# STATE OF OHIO DEPARTMENT OF TRANSPORTATION

## DEF-24-11.35

CONSTRUCT A NEW 0.42 MILE 2-LANE OVERPASS AT THE US24/CR 185 AT-GRADE INTERSECTION & REMOVE CURRENT INTERSECTION. THE PROJECT CONSISTS OF RAISING CR 185 OVER US24 ON THE EXISTING ALIGNMENT, CONSTRUCTING A NEW 2-SPAN BRIDGE & REMOVING INTERSECTION PAVEMENT ON US 24 & RESTORING US 24 TO A 4-LANE DIVIDED FACILITY.

ADDENDUM	NUMBER	DATE	DESCRIPTION
	1	02/14/2025	UPDATED DATE

GEOTECHNICAL PROFILE - ROADWAY  
 CULVERT NO. 1996358

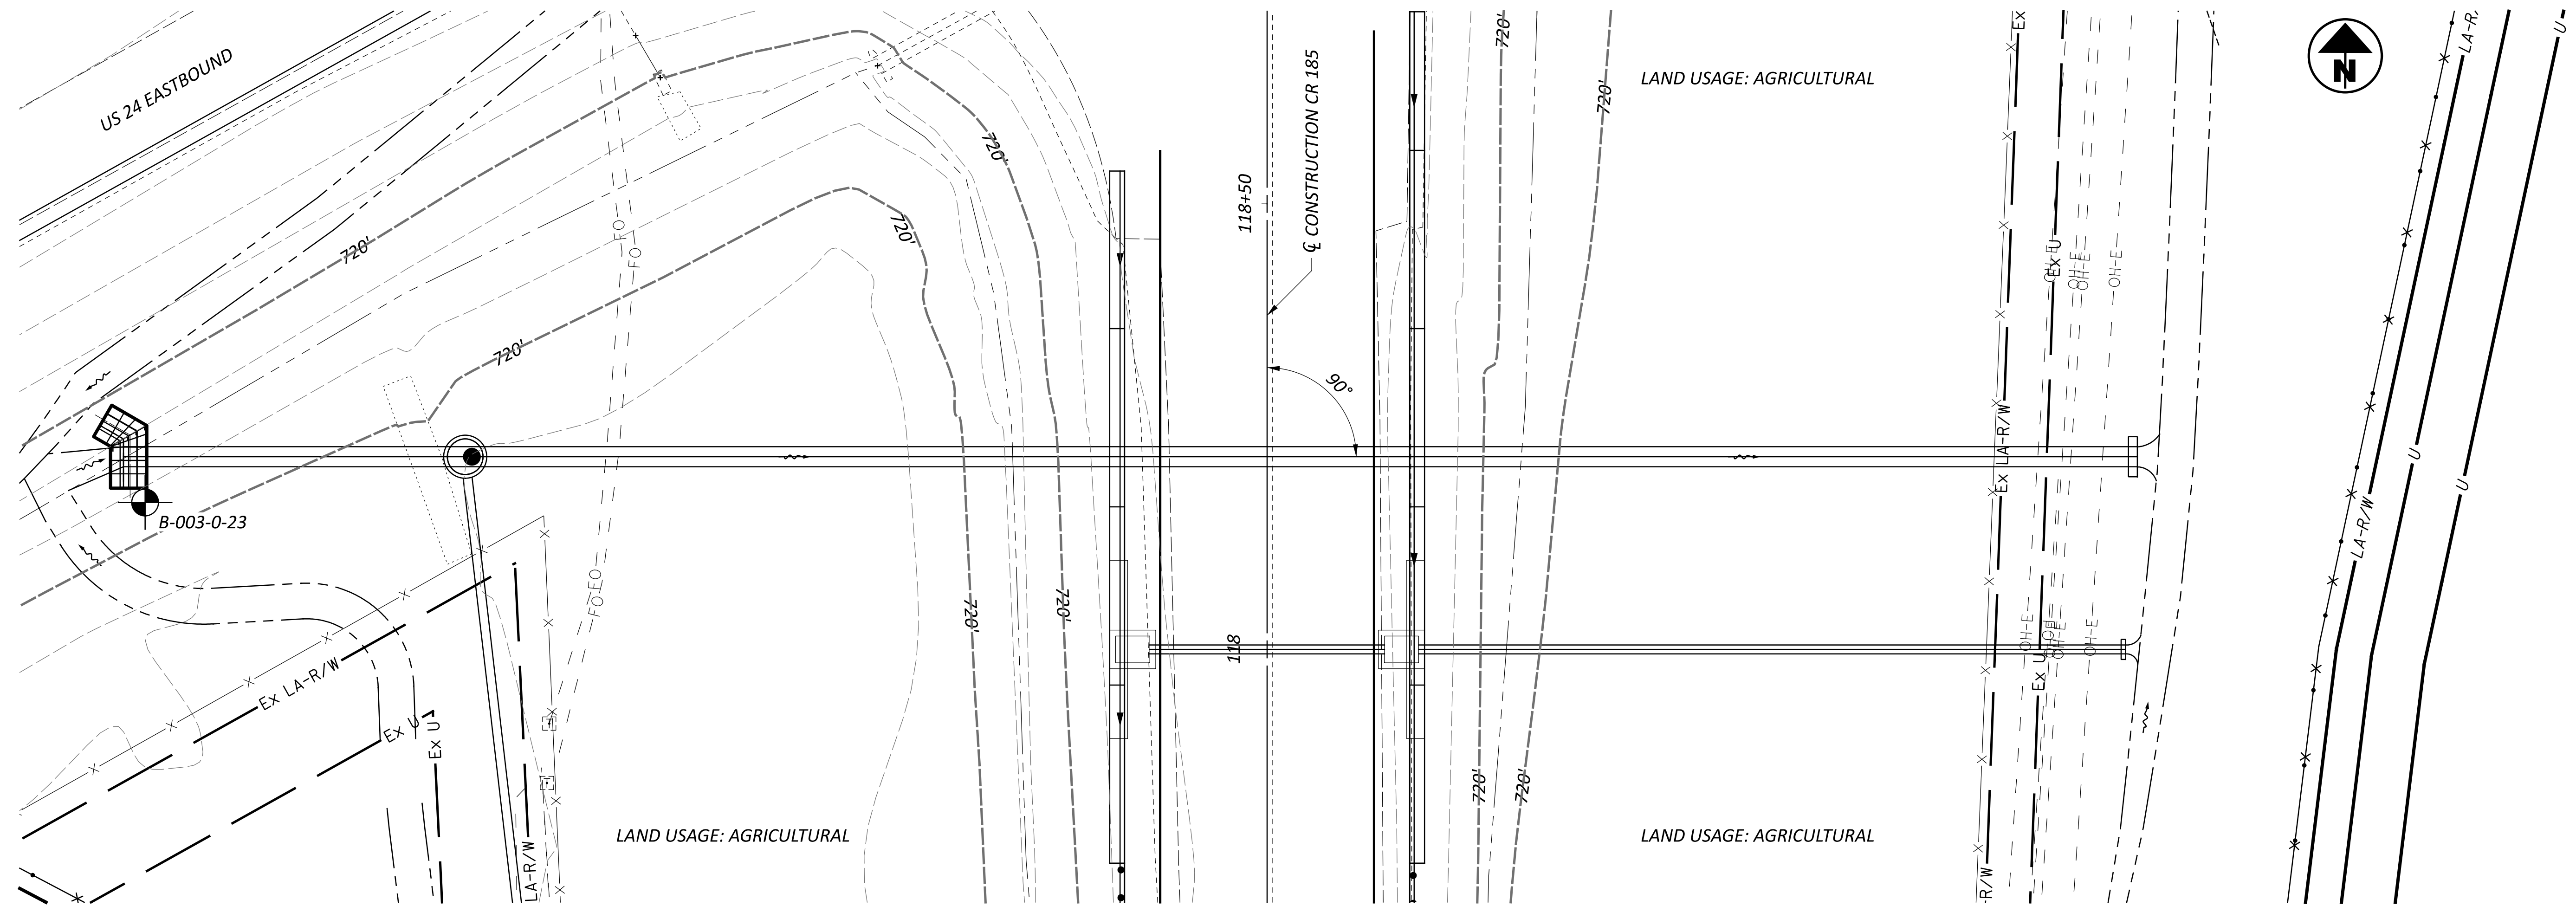
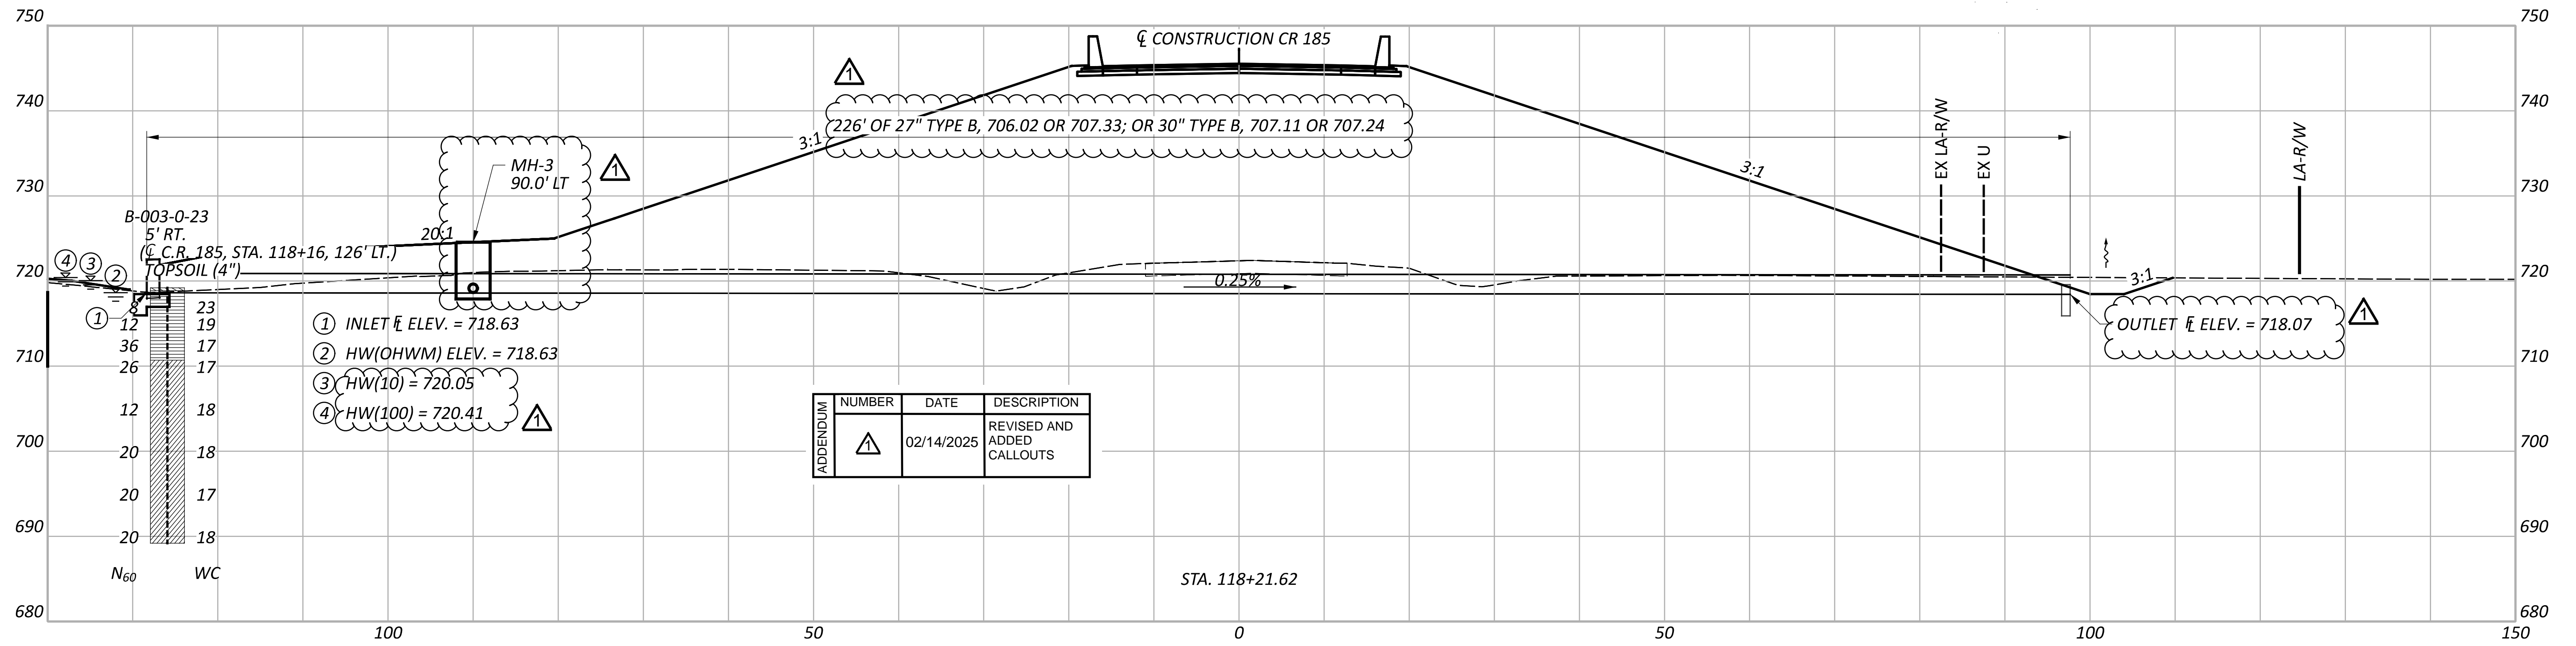
- ① INLET ELEV. = 718.63
- ② HW(OHWM) ELEV. = 718.63
- ③ HW(10) = 720.05
- ④ HW(100) = 720.41

APPENDIX	NUMBER	DATE	DESCRIPTION
△		02/14/2025	REVISED AND ADDED CALLOUTS

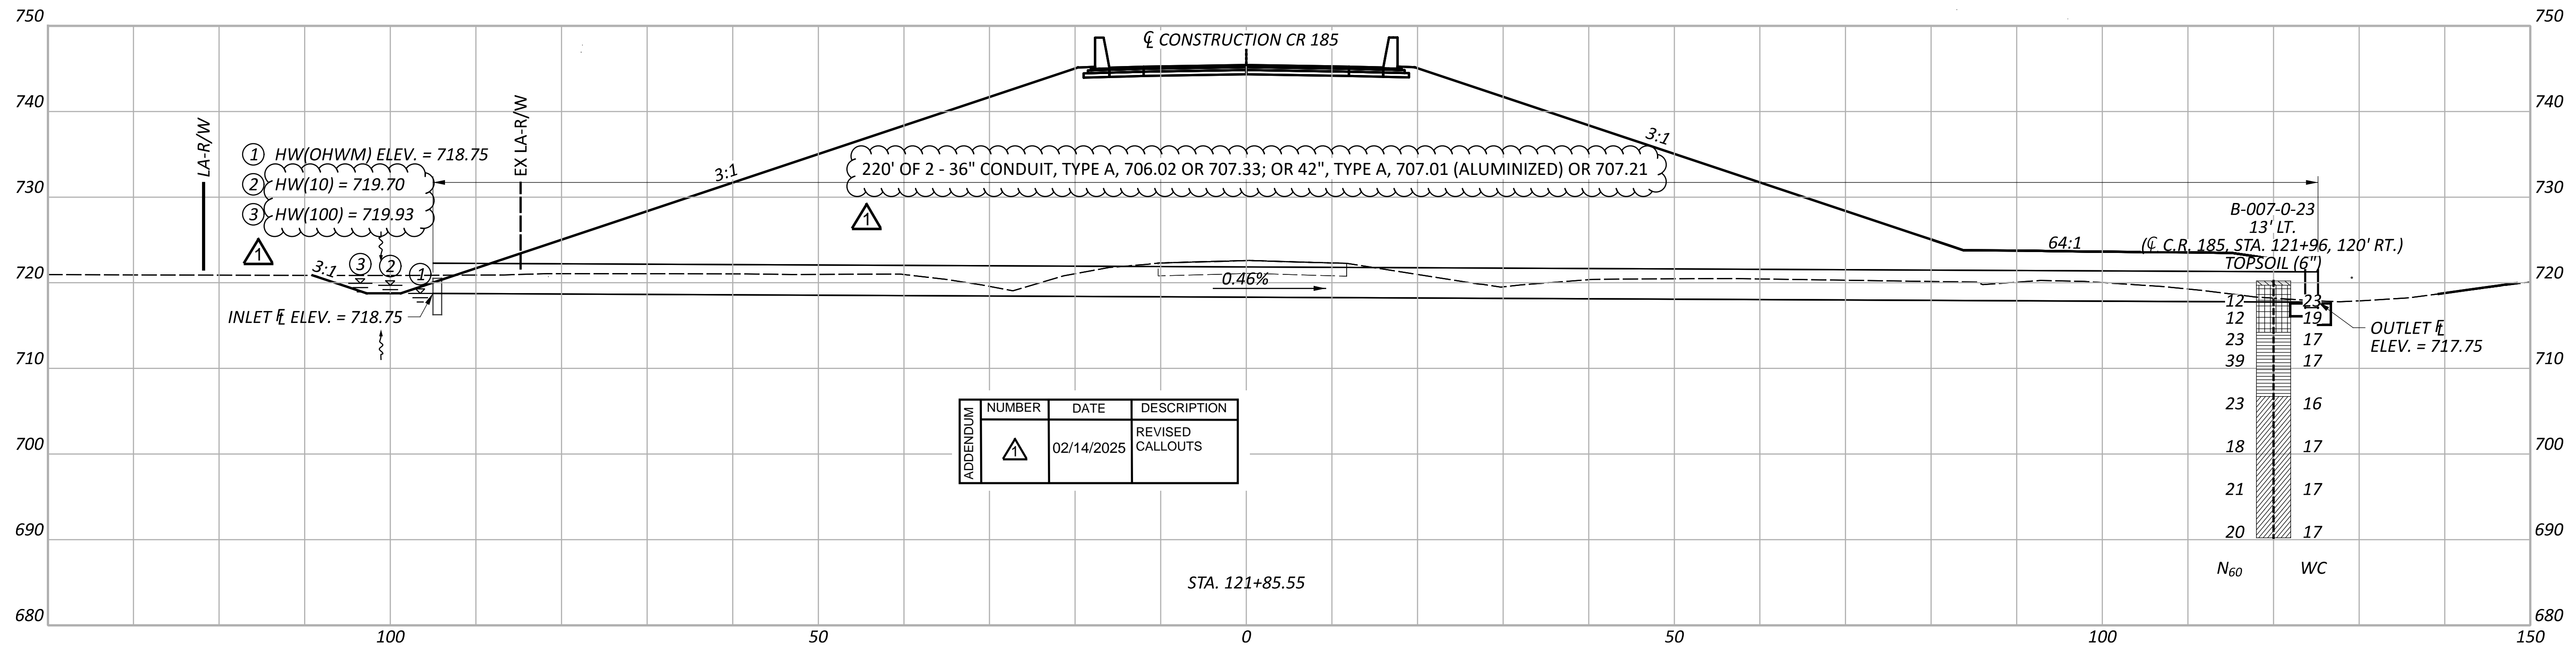
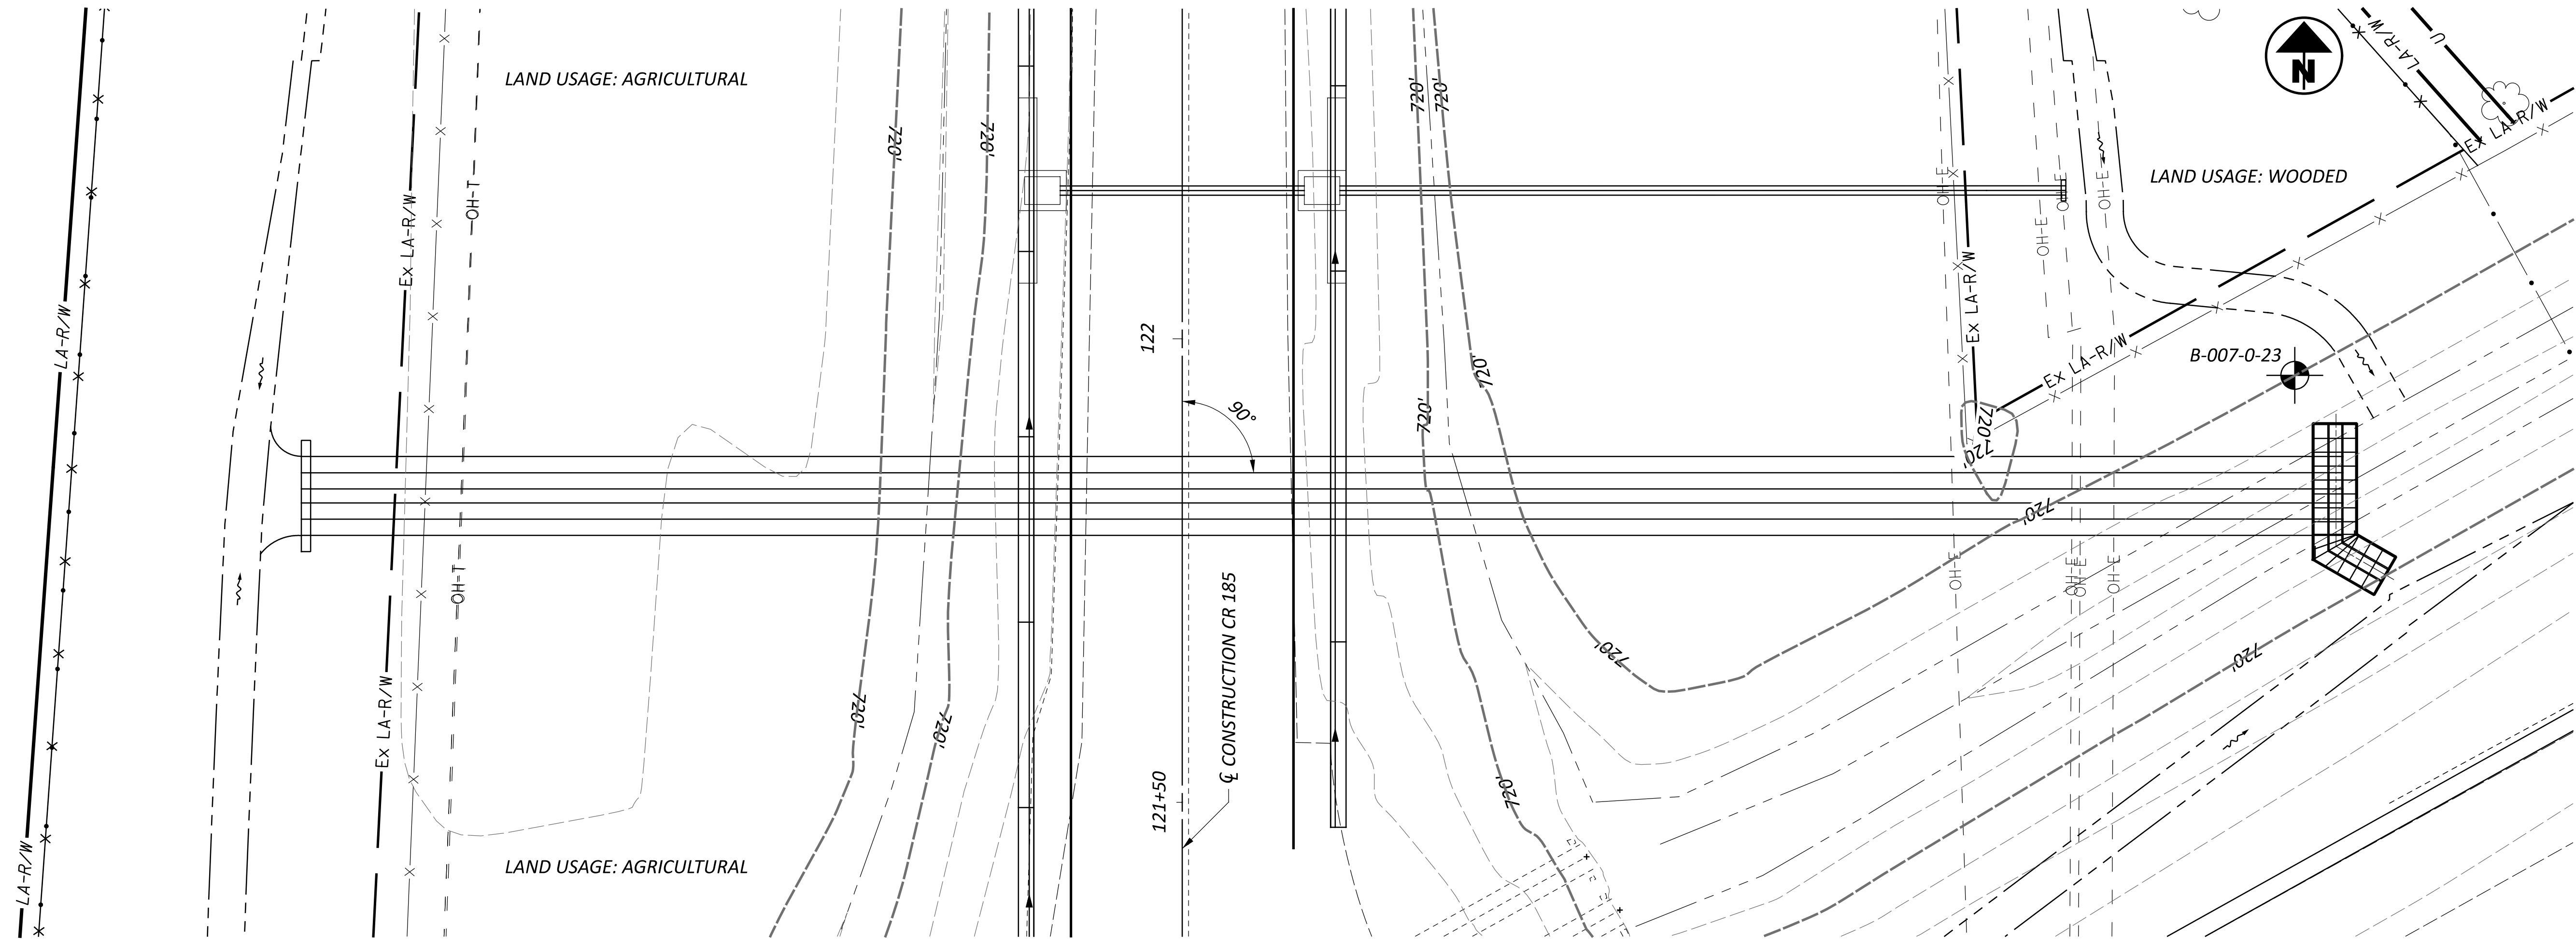
- ① HW(OHWM) ELEV. = 718.75
- ② HW(10) = 719.70
- ③ HW(100) = 719.93

ADDENDUM	NUMBER	DATE	DESCRIPTION
	△	02/14/2025	REVISED CALLOUTS
